49 CFR Part 572

Anthropomorphic Test Devices; 3-Year-Old Child Crash Test Dummy

ACTION: Final rule; response to petitions for reconsideration.

Figure P4

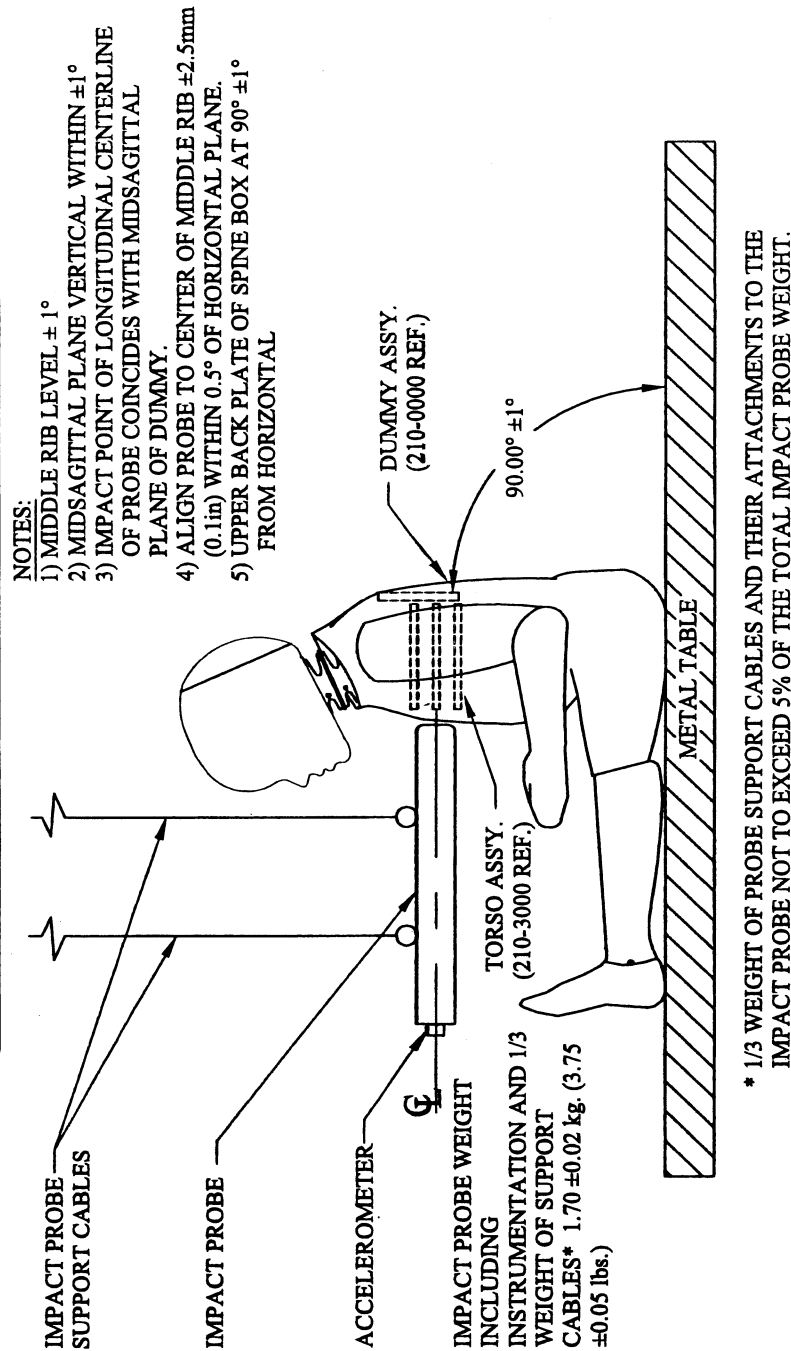
NHTSA's Response: NHTSA agrees that the tolerance of ± 0.02 lb might be difficult to achieve because some of the accelerometers used on the crash test equipment weigh as much as 0.02 lb while others are as low as 0.002 lb. The agency believes that the total impactor weight tolerance should, to the extent possible, take into account the weight differences between many possible types of accelerometers used on impactors. Accordingly, we agree with the Alliance recommendation to increase the overall weight tolerance to ± 0.02 kg (± 0.05 lb), which allows less than 3 percent variation in the overall weight of the impactor. The weight specification is also changed in Figure P4 of Part 572, Subpart P, titled "Thorax Impact Test Set-Up Specifications."

4. In § 572.146, revise paragraph (a), add paragraph (l)(2)(iv), and revise Figure P4 to read as follows:

concentric about its longitudinal axis. Any attachments to the impactor such as suspension hardware, and impact vanes, must meet the requirements of § 572.144(c)(7) of this part. The impactor shall have a mass of 1.70 ± 0.02 kg (3.75 ± 0.05 lb) and a minimum mass moment of inertia 164 kg-cm^2 ($0.145 \text{ lb-in-sec}^2$) in yaw and pitch about the CG of the probe. One-third ($\frac{1}{3}$) of the weight of suspension cables and any attachments to the impact probe must be included in the calculation of mass, and such components may not exceed five percent of the total weight of the test probe. The impacting end of the probe, perpendicular to and concentric with the longitudinal axis of the probe, has a flat, continuous, and non-deformable 50.8 ± 0.25 mm (2.00 ± 0.01 inch) diameter face with an edge radius of 7.6/12.7 mm (0.3/0.5 in). The impactor shall have a 53.3 mm (2.1 in) dia. cylindrical surface extending for a minimum of 25.4 mm (1.0 in) to the rear from the impact face. The probe's end opposite to the impact face has provisions for mounting an accelerometer with its sensitive axis collinear with the longitudinal axis of the probe. The impact probe has a free air resonant frequency not less than 1000 Hz limited to the direction of the longitudinal axis of the impactor.
